**Re: *Pioneer Valley Energy Center, Westfield, Massachusetts  
Prevention of Significant Deterioration Air Permit Application  
Information Request Response  
ESS Project Number E402-007.01***

On behalf of Pioneer Valley Energy Center, LLC (PVEC), ESS Group Inc (ESS) is providing the following supplemental information to the above referenced application in response to your request for additional information dated May 17, 2011.

**Figure**  
**1A**

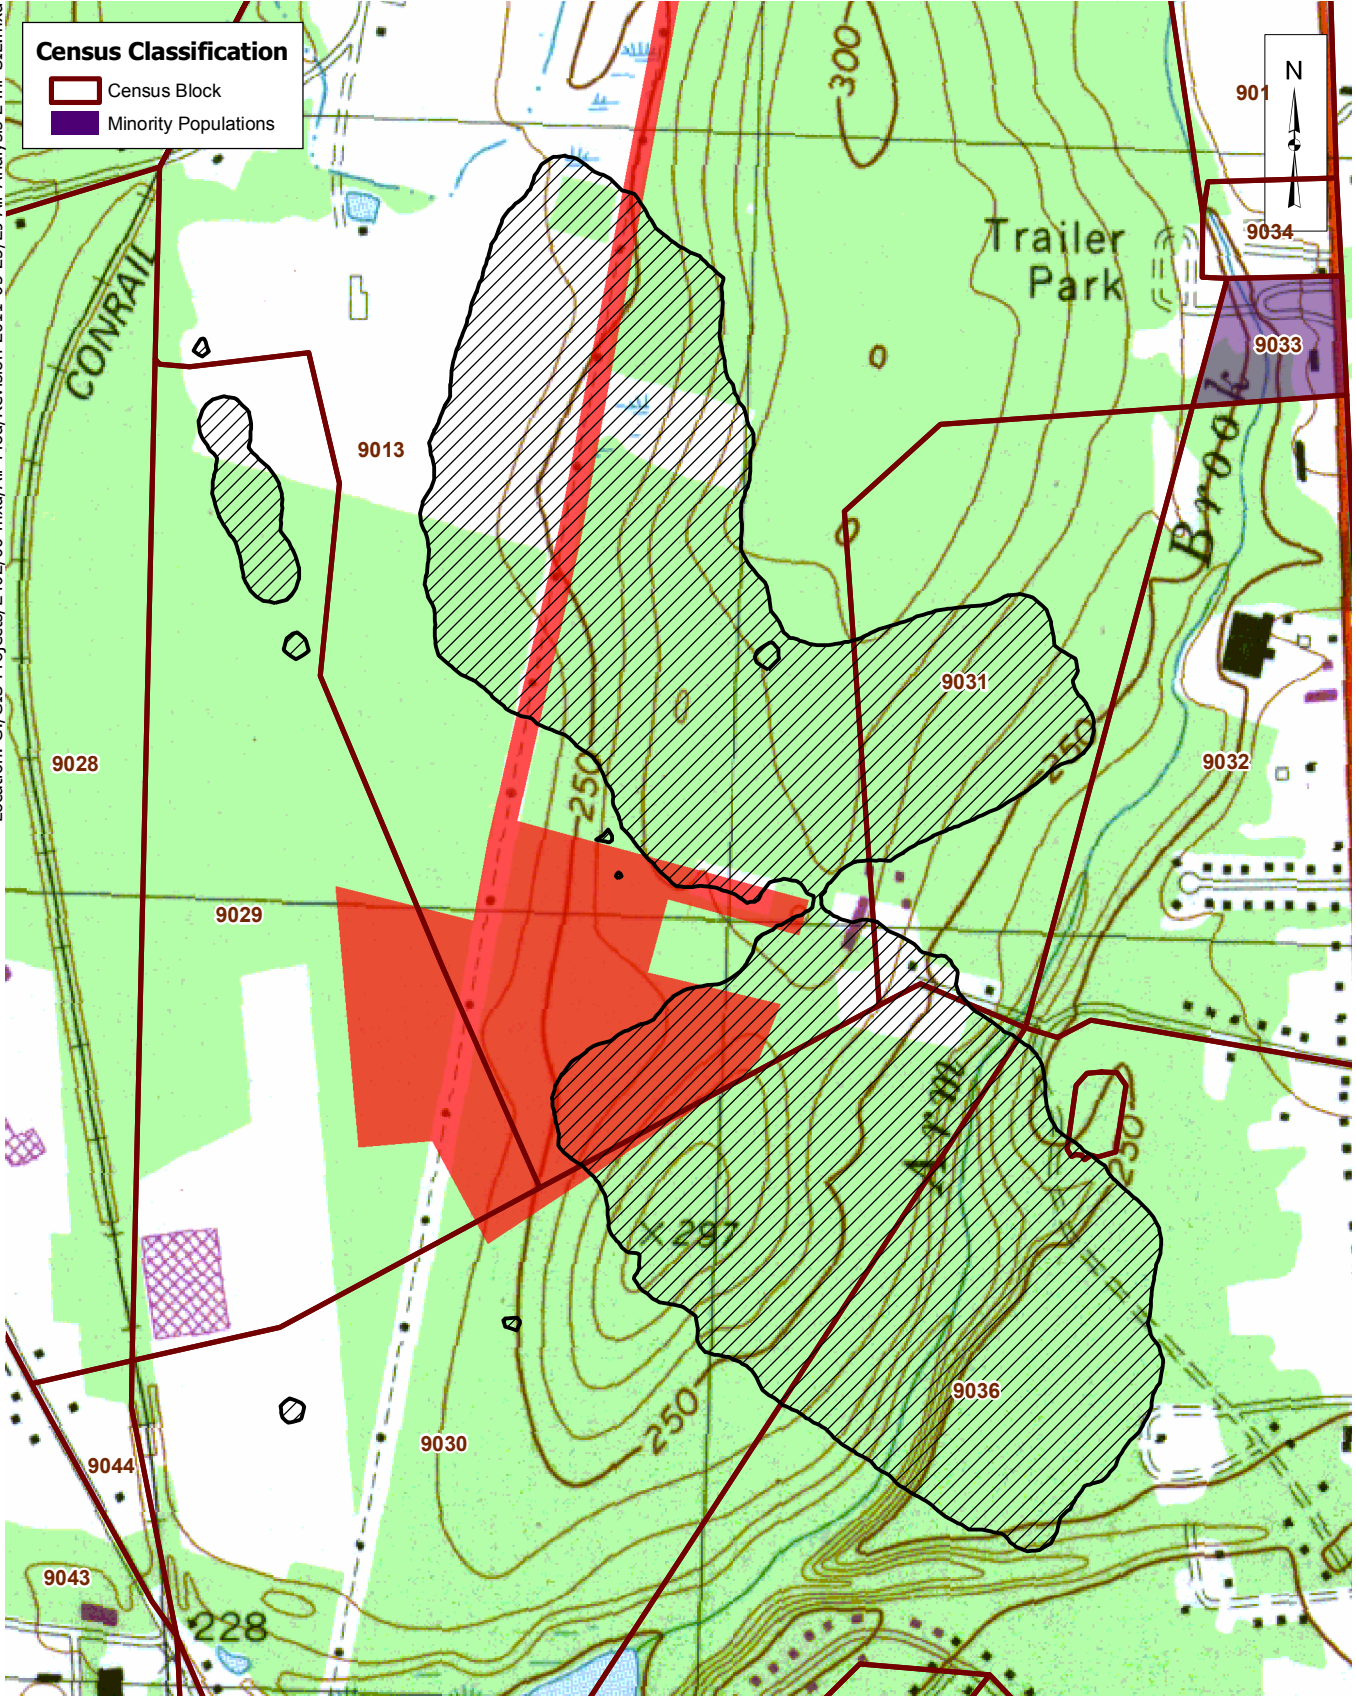
1. The EPA has requested that PVEC provide figures which magnify the significant impact areas (SIA) for annual and 24-hour PM<sub>2.5</sub>. The attached figures (Figures 1A and 2A) provide such detail. As shown on Figures 1A and 2A, neither the SIA for annual nor 24-hour PM<sub>2.5</sub> include any identified environmental justice areas.
